PREPARED FOR THE PLAN COMMISSION

Project Address: 416-446 W Washington Avenue and 413-417 W Mifflin Street
Application Type: Demolition Permit, Conditional Use, and Certified Survey Map Referral
Legistar File ID # [85416](#), [85418](#), and [85420](#)
Prepared By: Chris Wells, Planning Division
Report includes comments from other City agencies, as noted.
Reviewed By: Kevin Firchow, AICP, Principal Planner
Meagan Tuttle, AICP, Planning Division Director

Image 2: Path of the Proposed Publicly Accessible Walkway through the Project Site and Shared Cross-Access that must be maintained with the Residence to the 2-Unit at 409 W Mifflin Street

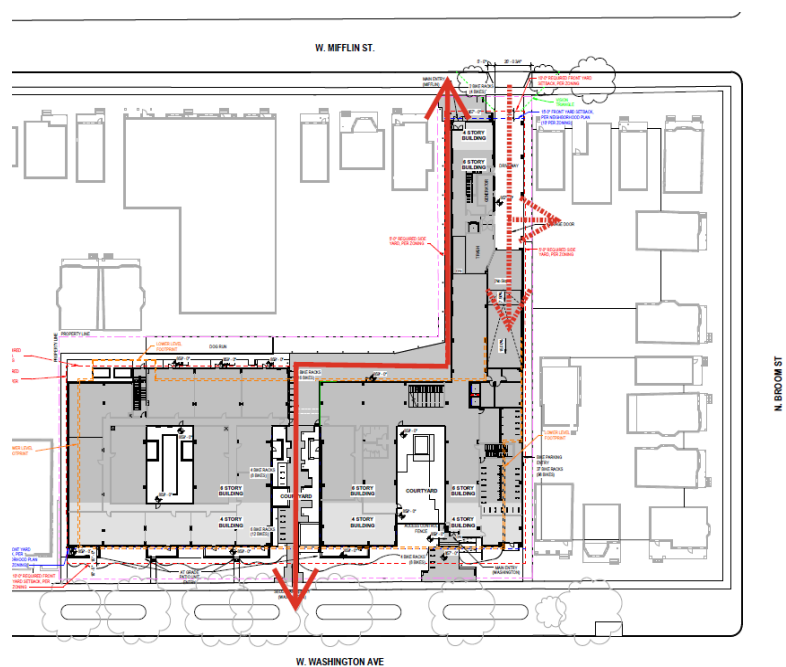
Additionally, the [Mifflandia Plan](#) includes a recommendation to “consider” the construction of an east-west “Interblock Lane” within the subject block. Such a lane could function as a rear-lot alley, paralleling W Washington Avenue through the entirety of this block. The concept was further described as an opportunity to facilitate additional rear-yard development, limit driveways onto W Washington Avenue, and reduce potential vehicle bike conflicts.

Compared to some other design recommendations in the plan, staff believes this particular recommendation is less binding, phrased only as an item to be considered. Nevertheless, the proposed development does not account for this feature. Staff note that there are multiple challenges in establishing such a connection at this time, including a number of existing structures outside of the project site that would also make the creation of such a lane

impossible until these structures are removed and/or the sites redeveloped. Staff also note that while a much smaller development, the adjacent site at 423-427 W Mifflin Street was approved at the November 18, 2024 Plan Commission without any recommendations or conditions to accommodate such a connection.

Image 3: Potential location of historic information/imagery regarding Edward Schildhauer near the east corner of the proposed building’s ground floor

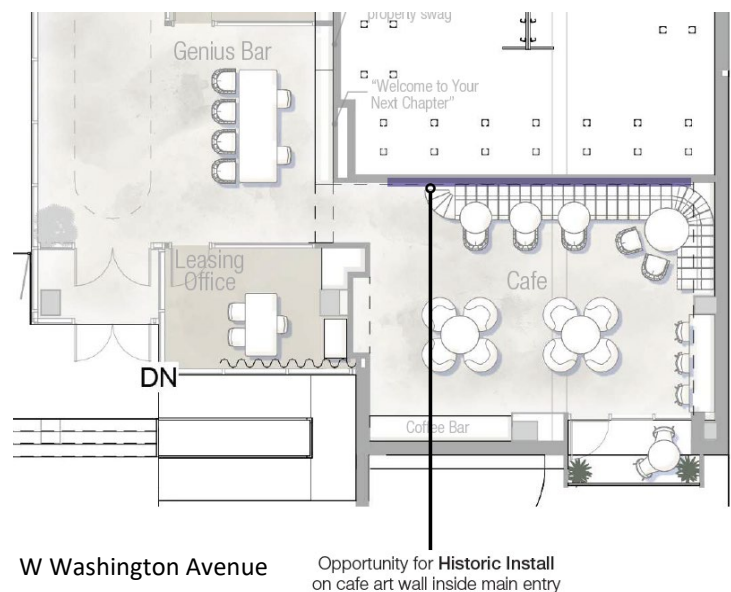
In response to the historic significance of the structure at 418 W Washington Avenue, the applicant has a proposed mitigation to identify an area by the front door / resident café area in the lobby of the new building to include some information and imagery of Edward Schildhauer and the house to tell the history. Please see Image 3 for the proposed location of the information/imagery, which is near the footprint of the subject building today. The applicant notes that they did something similar at their recent development at S Park Street and Regent Street (Legistar File IDs [71244](#) and [71245](#)) which involved the demolition of several buildings related to the City’s Italian community’s history as well as that of the Greenbush neighborhood.
